# **EXPLANATION OF SIGNIFICANT DIFFERENCES**

## **SHEPLEY'S HILL LANDFILL SUPERFUND SITE FORMER FORT DEVENS ARMY INSTALLATION**

### **LAND USE CONTROLS TO RESTRICT GROUNDWATER USE**

### Response to Comments

**Figure 3**  
**Area of Land Use Controls: North Impacted Area**

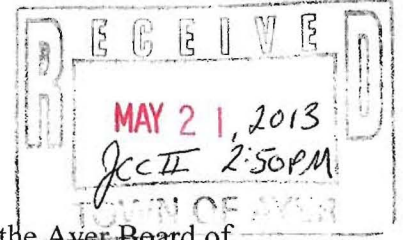
*The LUC boundary is approximately 400 feet from the edge of the northern impact area, not the Fort Devens’ property boundary. Any institutional controls will refer to the LUC boundary on a map (Figure 3) not distances from property boundaries. Therefore this extended boundary will create an additional buffer from the impacted groundwater. Figure 3 of the ESD depicts the area to be restricted under the LUCs and will be included in the moratorium developed with the Town of Ayer.*

Second bulleted paragraph of 3.1.2: The Town of Ayer’s Moratorium restricts the use of groundwater in “documented or anticipated areas of groundwater contamination as defined by the Ayer Board of Health.” These areas are not necessarily identical to the “Area of Land Use Controls” described in Figure 3 of the ESD, which extends 400 feet from the limits of groundwater contamination. Delete “within the Area of Land Use Controls” after “(Attached as Appendix B)”. Delete “within the Area of Land Use Controls as defined by Figure 3 (including any future revisions)” and replace with “within documented or anticipated areas of groundwater contamination as defined by the Ayer Board of Health.” Add the following sentence: “The Army will be responsible for ensuring that the Town of Ayer applies the Moratorium

*Since the Town of Ayer Moratorium did not reference Figure 3 - Area of Land Use Control, the text has been revised accordingly as follows:*
